Report on Consultation - Route Selection

Project: LT337 Tangy IV Wind Farm OHL Connection

Date: April 2023

Plate 5.1 – Revised Preferred Route

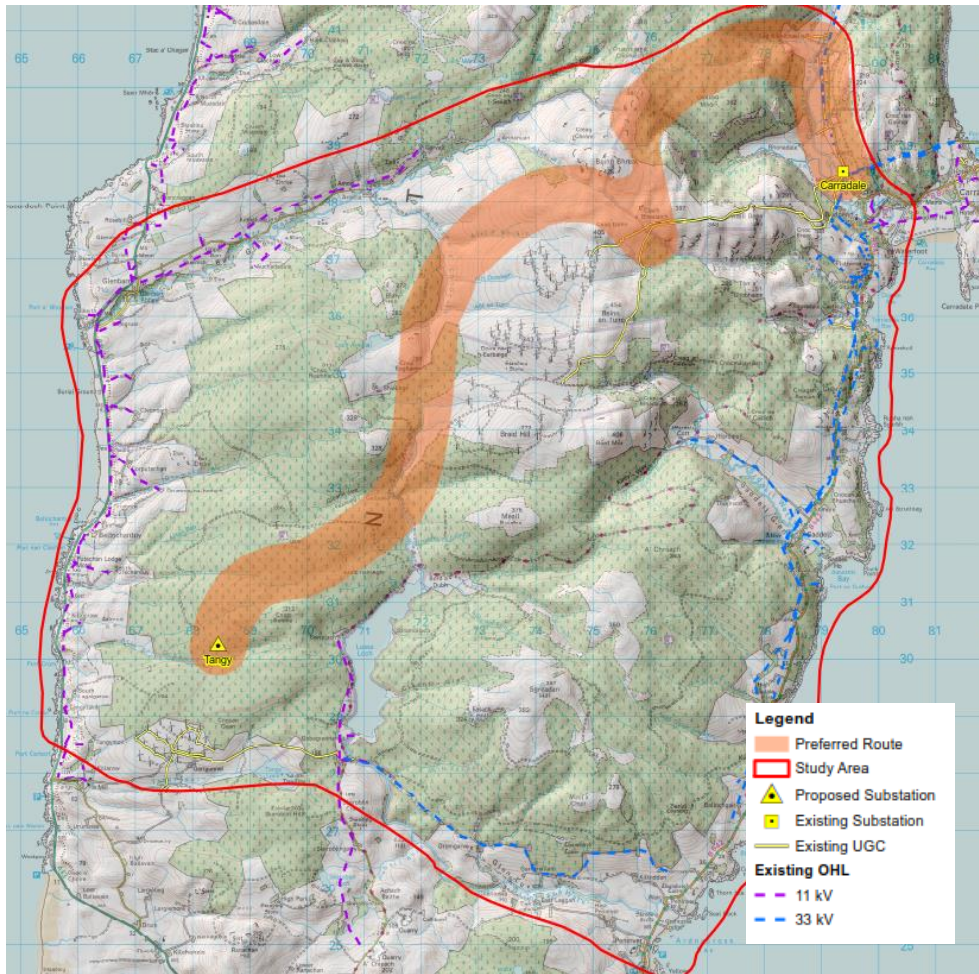
Feedback received from consultees including RSPB Scotland, Historic Environment Scotland, Scottish Forestry and Argyll Fisheries Trust reflected that a change to Route Options A2 and B2 would avoid potential disturbance of habitats that are important for Atlantic Salmon and sea trout populations; preferable options to reduce collision risk for birds including Greenland white-fronted goose and black grouse; likely to require less transiting of areas of ancient woodland; and likely to have a much lesser impact on historic environment interests than Route Options A1 and B1. As such, SSEN Transmission presented a revised Preferred Route comprising of Route Options A2, B2 and C1 as a preferable option for seeking consultee feedback on. The revised Preferred Route is shown in **Plate 5.1**.
